OCONEE NUCLEAR STATION, UNITS 1 & 2

AMENDMENTS TO FACILITY OPERATING LICENSES

Amendment No. 1
License Nos. DPR-38 and
DPR-47

SAFETY EVALUATION BY THE DIRECTORATE OF LICENSING
SUPPORTING AMENDMENT NOS. 1 TO LICENSE NOS. DPR-38 AND DPR-47
(CHANGE NOS. 11 AND 6 TO APPENDIX A OF TECHNICAL SPECIFICATIONS)

CONTROL ROD GROUP WITHDRAWAL
 LIMITS FOR 3 AND 2 PUMP OPERATION

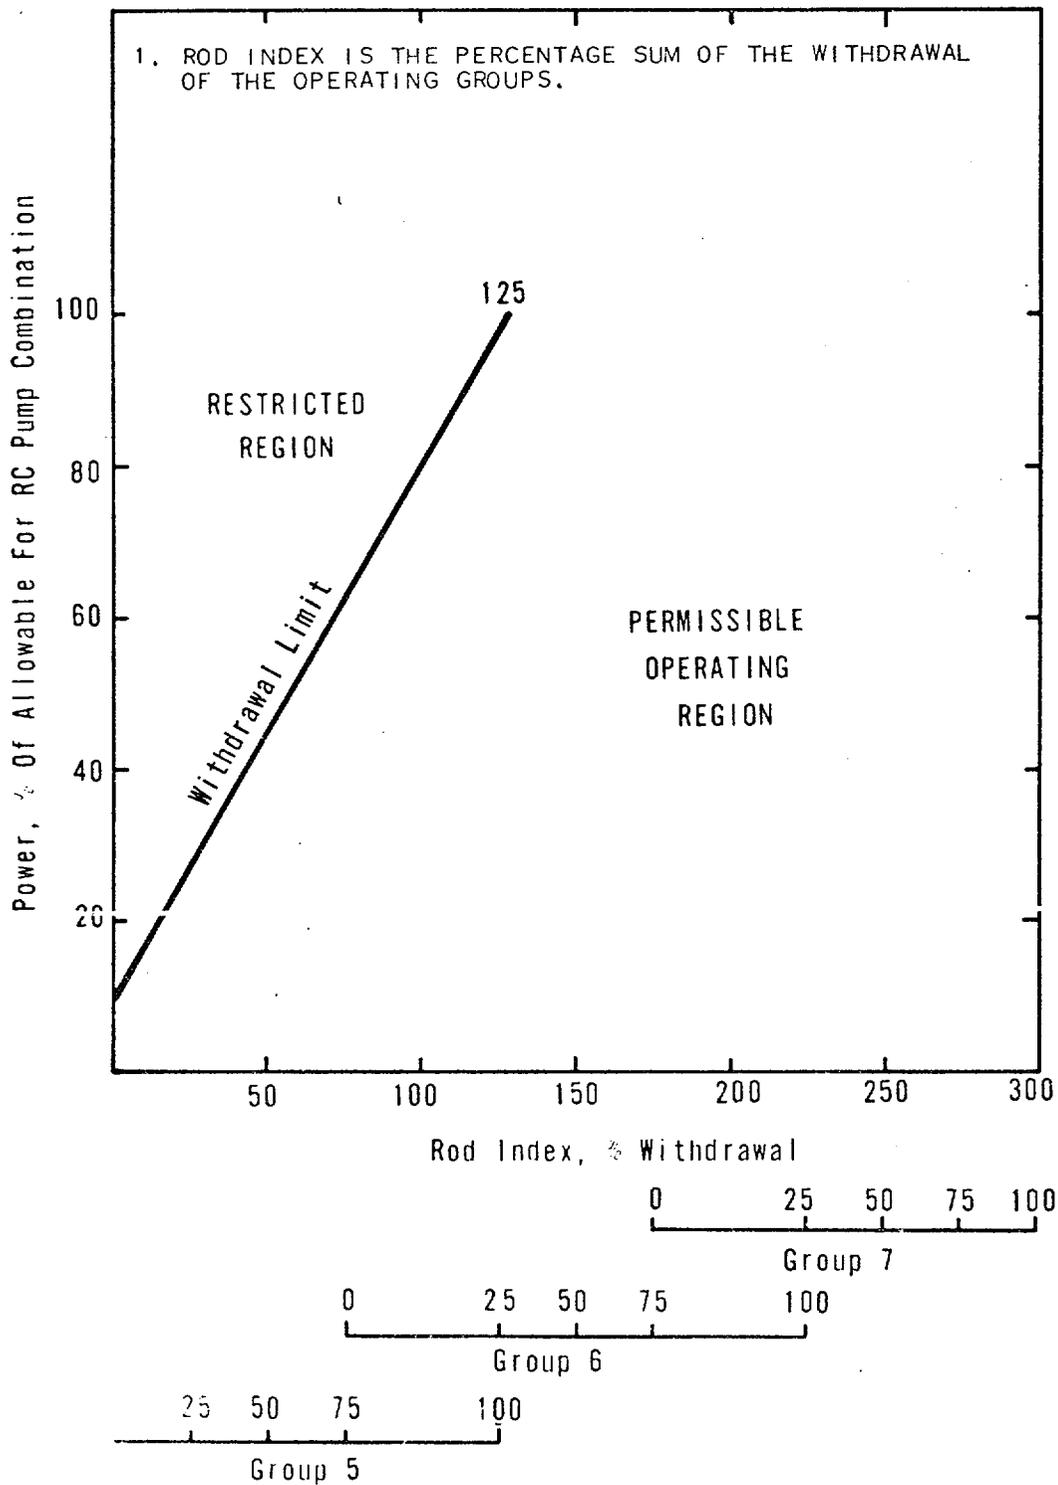
The control rod withdrawal limits given in Technical Specification 3.5.2.5c are specified in separate figures for Oconee Unit 1 and Oconee Unit 2. The control rod withdrawal limits for Oconee Unit 2 are only slightly changed from those in the current Technical Specifications; the changes primarily reflect the reduction in the quadrant power tilt limit from 5 to 4 percent. Oconee Unit 1 control rod withdrawal limits are changed considerably. The changes in the limits are made possible by items (1) through (3) listed above as "Bases for Changes in the Technical Specifications", and primarily by item (2), the higher fuel density in the Oconee Unit 1 core. Evaluation of the new rod withdrawal limits, in combination with other changes discussed in the safety evaluation, against previously approved core power peaking factors shows that the factors are not increased. Previously approved design margins of safety are maintained.

An addition has been made to the control rod withdrawal limit Technical Specification which requires that, if control rod withdrawal limits are reached, corrective action to achieve acceptable control rod positions must be taken immediately. Acceptable control rod positions must be attained within two hours. The intent of this addition to the Technical Specification is not to provide a broader operational control rod band, but to provide a small margin in time to achieve the proper boration/deboration of the coolant.

- (1) If four reactor coolant pumps are in operation, the allowable thermal power shall be reduced by 2 percent of full power for each 1 percent tilt in excess of 4 percent below the power level cutoff (see Figures 3.5.2-1A1, 3.5.2-1A2, 2.5.2-1B1 and 3.5.2-1B2).

UNIT 1 (First Fuel Cycle)
OCONEE NUCLEAR STATION
Figure 3.5.2-3A

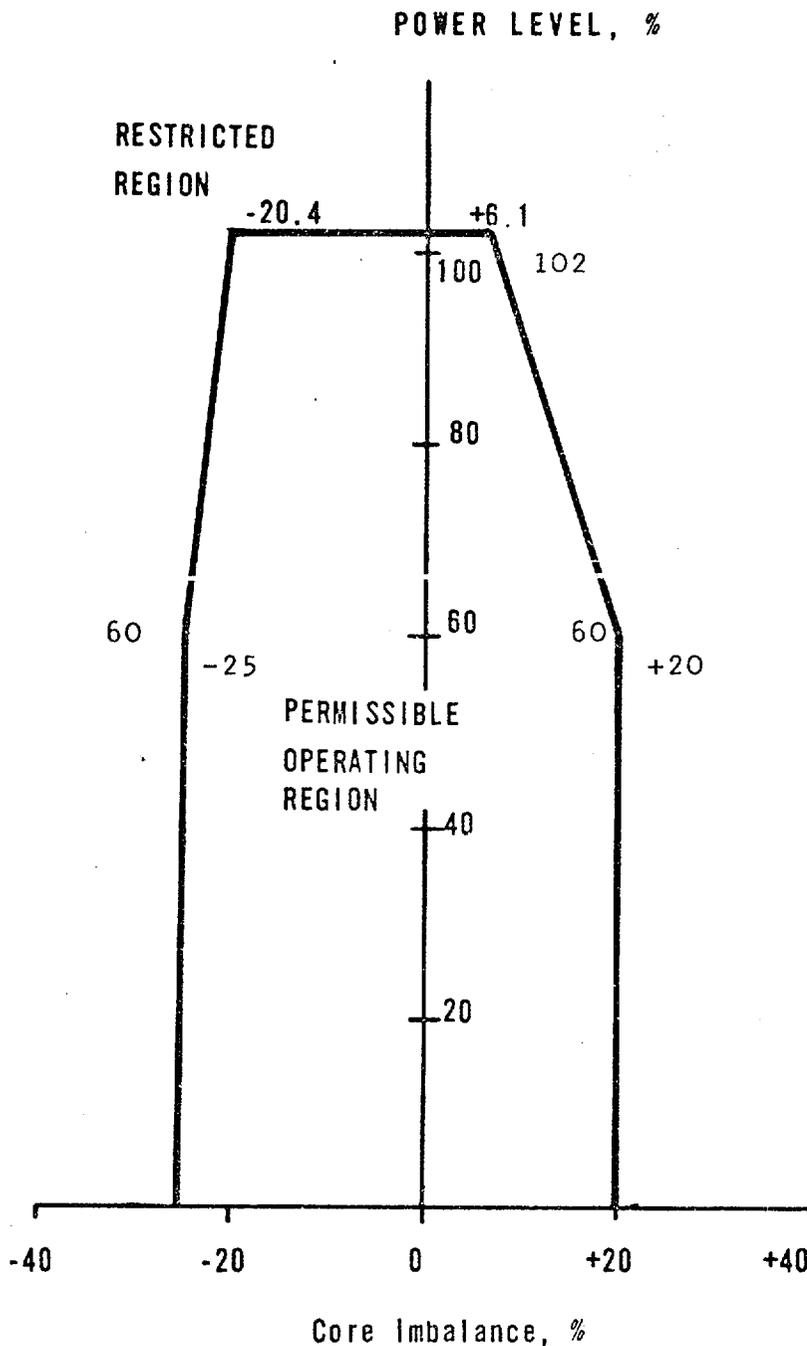
A modification has been made in the reactor power imbalance Technical Specification (3.5.2.6). If the imbalance is not within the envelope of the figures provided, then an acceptable imbalance must be achieved within two hours or else a decrease in power must be made until imbalance limits are met. Previously, a four hour period was allowed to achieve imbalance limits.

New figures for Oconee Units 1 and 2 are provided for the imbalance limits. These figures indicate an increase in the negative imbalance

limits due to margins in the power peaking factors available in the analysis provided in BAW-10078 and in the quadrant tilt limit.
